CITY OF EL PASO, TEXAS
AGENDA ITEM DEPARTMENT HEAD'S SUMMARY FORM

An Ordinance changing the zoning of a Lot 48, Block 4, Stiles Gardens, City of El Paso, County of El Paso, Texas, from R-5 (Residential) to S-D (Special Development). The penalty is as provided for in Chapter 20.24 of the El Paso City Code. Subject Property: 7121 Stiles Drive A & B. Property Owner: Clotilde Hidalgo. PZRZ13-00008 (District 3)

City of El Paso – City Plan Commission Staff Report

Case No: PZRZ13-00008
Application Type: Rezoning
CPC Hearing Date: June 13, 2013
Staff Planner: Michael McElroy, 915-541-4238, mcelroyms@elpasotexas.gov
Location: 7121 Stiles Drive A & B
Legal Description: Portions of Lot 48, Block 4, Stiles Gardens, City of El Paso, El Paso County, Texas
Acreage: 0.433 acres
Rep District: 3
Zoning: R-5 (Residential)
Existing Use: Single-Family Home / Plumbing & HVAC / Auto Storage and/or Repair
Request: S-D (Special Development)
Proposed Use: Apartment Complex (Related to PZDS13-00005)
Property Owner: Clotilde Hidalgo
Representative: Jesus Jaime

ATTACHMENT 3: DETAILED SITE DEVELOPMENT PLAN

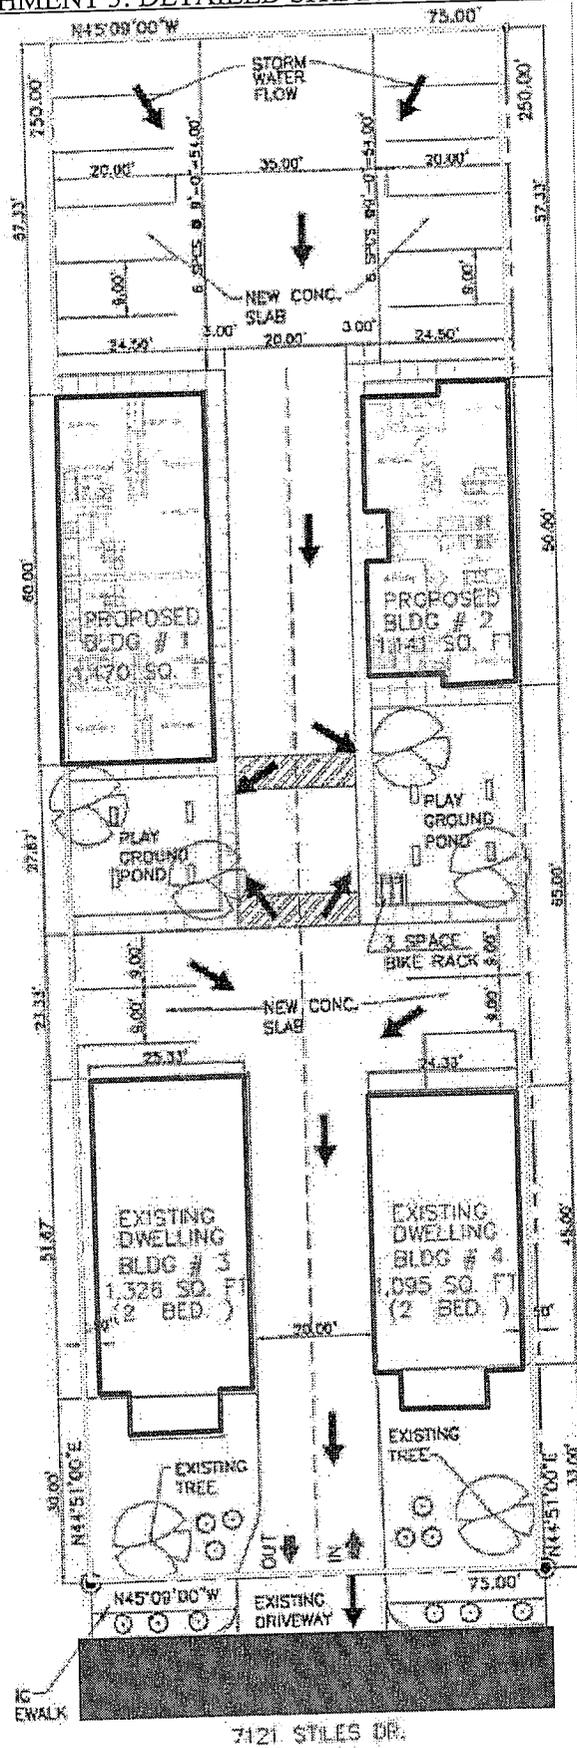
Recommend “APPROVAL” of “Detailed Site Plan” as presented. *****NOTE ***** PZRZ 13-00008 In accordance with the requirements of the Zoning Code Section 20.04.160 Content of application the Fire Planning Division has reviewed the submitted “Detailed Site Plan” for the following: Elevations, Perspective of the building, Dimensions, square footage and height of all structures, Number of dwelling units in Multi-family structures, and Driveways as applicable to following sections of the fire code; Sections 503 and Appendix D Fire Apparatus Access Roads, Section 903 Automatic Sprinkler Systems, Section 905 Standpipe Systems. “When required as per section 905.3.1, 905.4 and 905.5 all fire protections system plans shall be submitted separately to Fire Plan Review for further requirements and comments”. The Fire Planning Division has reviewed the submitted “Detailed Site Plan” as per requirements of the Zoning Code Section 20.04.160 Content of application and has determined that the submission DOES Comply within the zoning regulations.
